**Re: Desert Willow Apartments Certification of Grading and Drainage Plan
Engineer's Stamp dated 1-21-98 (C17/D20)
Certification date 11-24-99**

RE: Drainage Report Addendum to Desert Willow Apartments (C17/D20), Engineer's Stamp Dated 7/7/99.

Drainage Report Addendum to **Desert Willow Apartments**

RUNOFF FLOW PATH

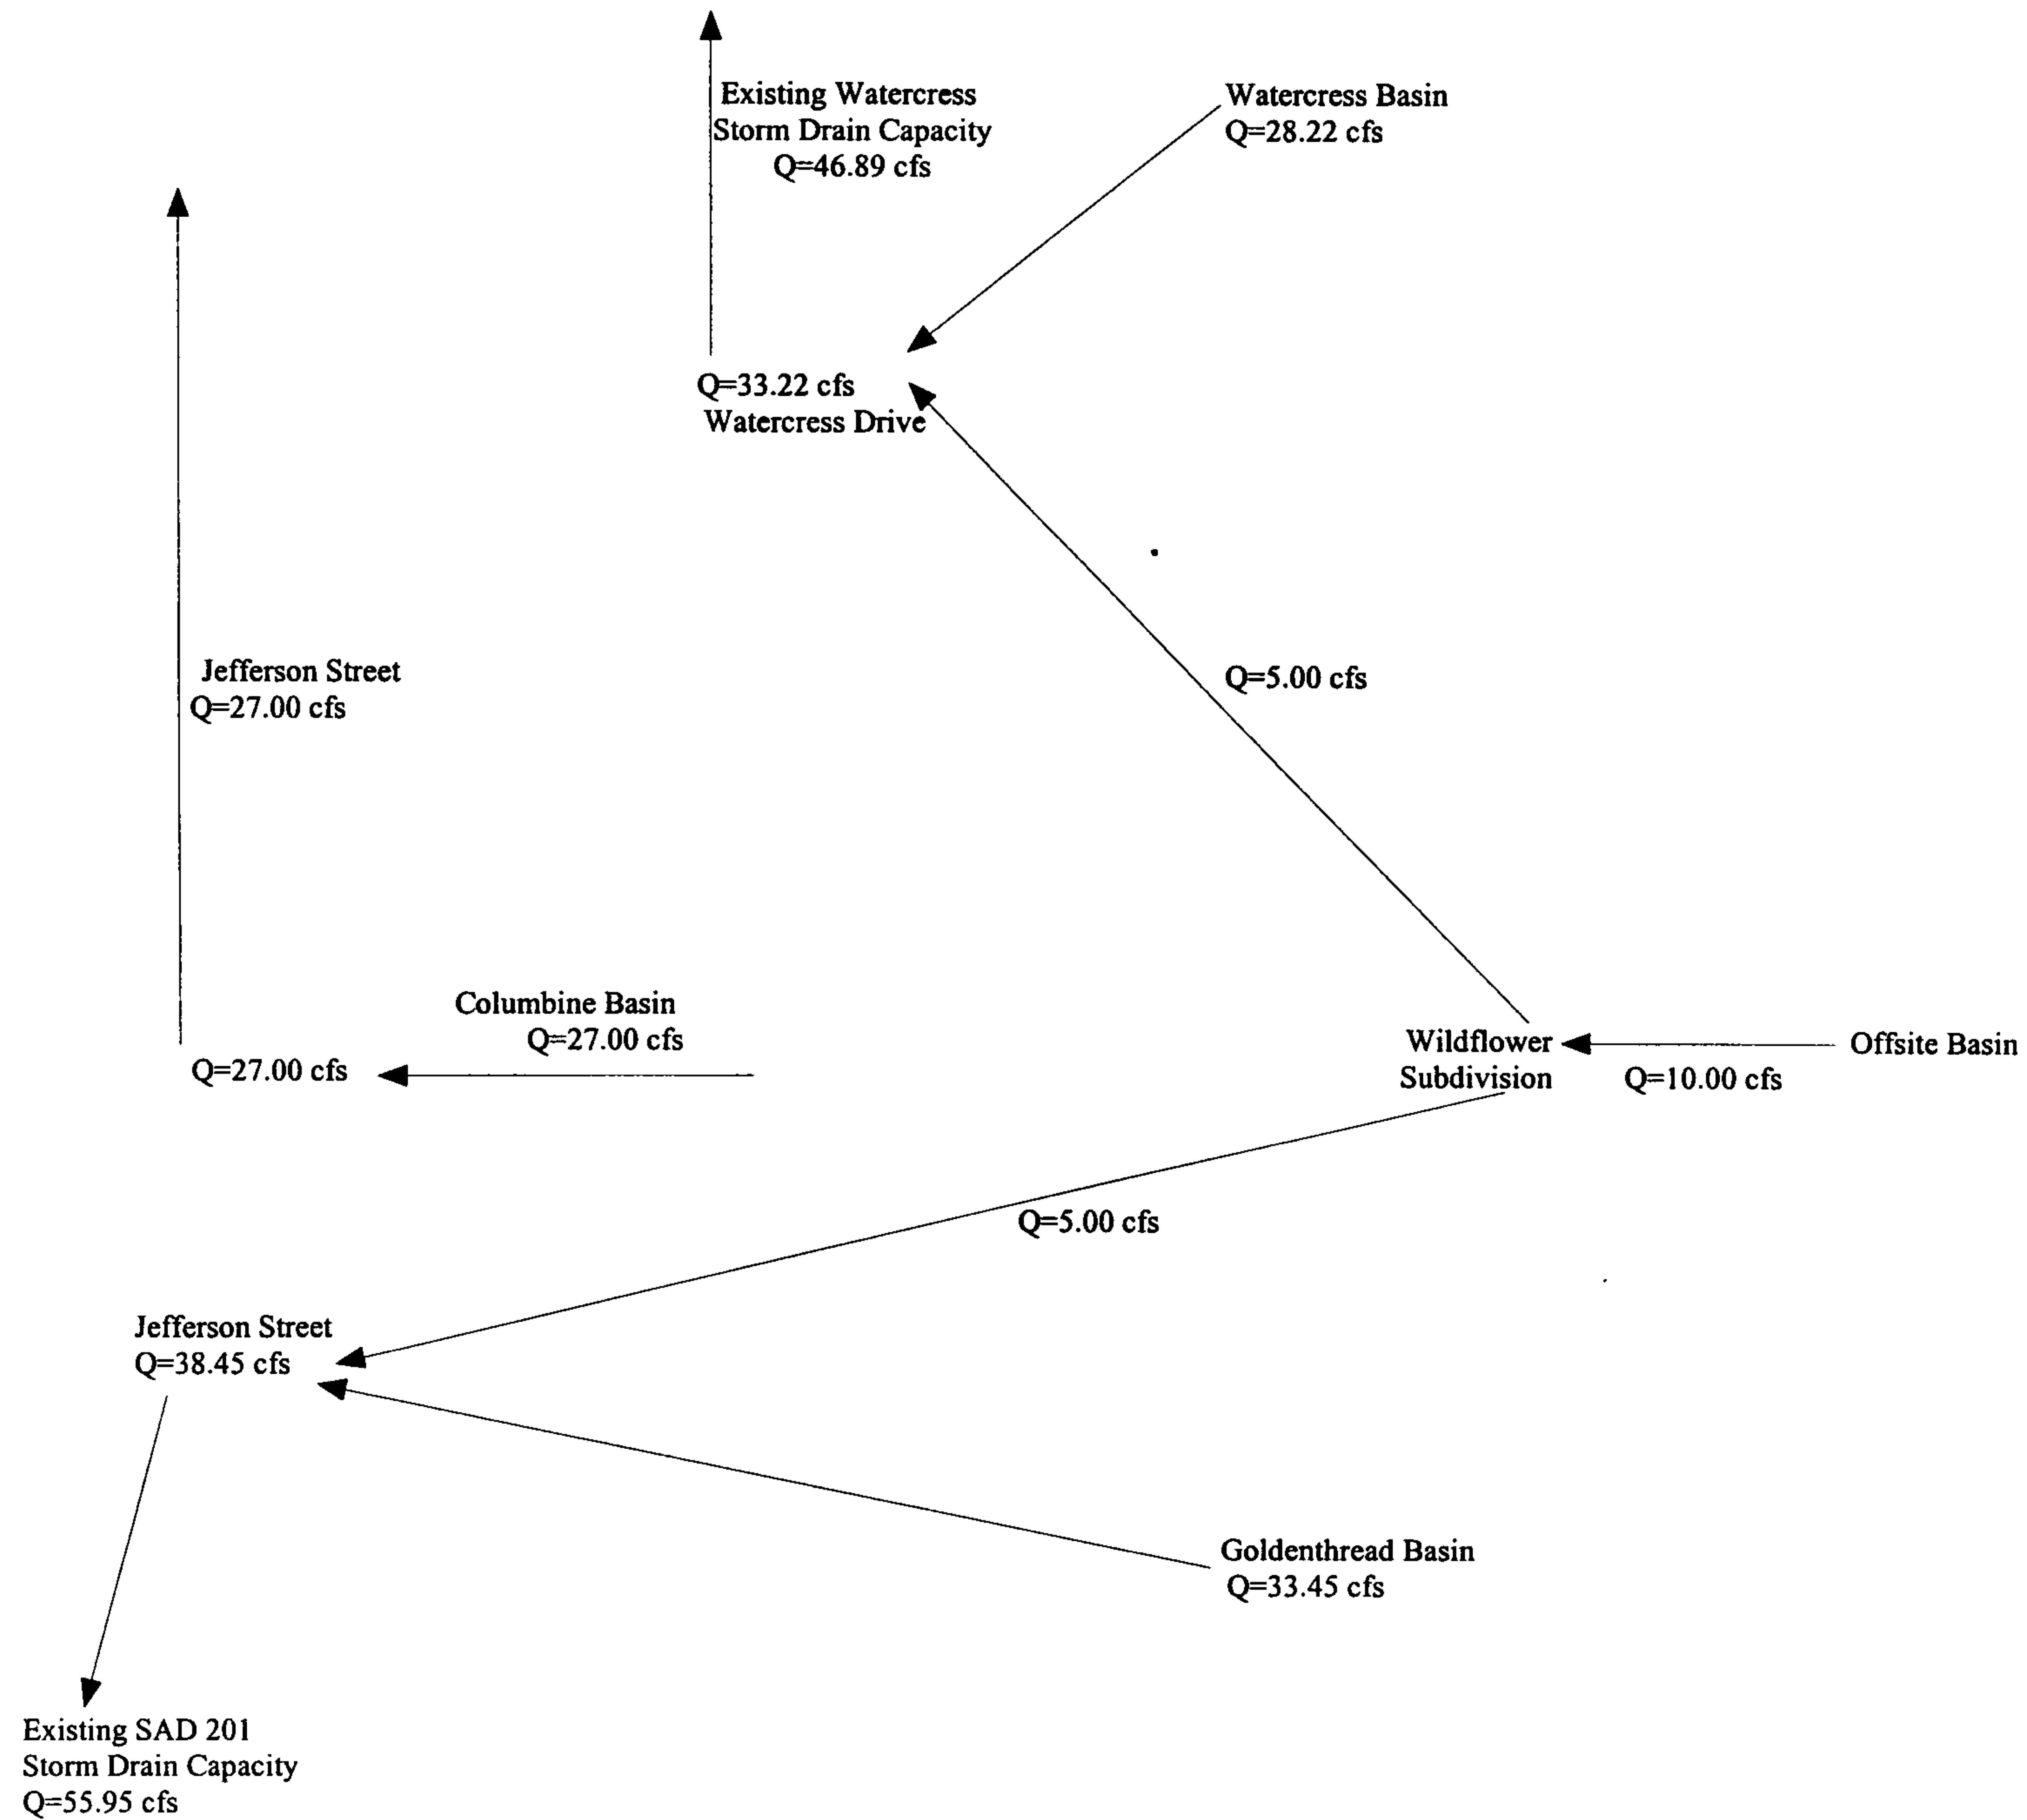
Based on the information provided in the above referenced Addendum, the elimination of the additional storm drain in Jefferson Street is appropriate. The Addendum demonstrates that the storm drain in Jefferson is not needed, therefore, the construction drawings for this storm drain should be deleted from the Work Order plan set.
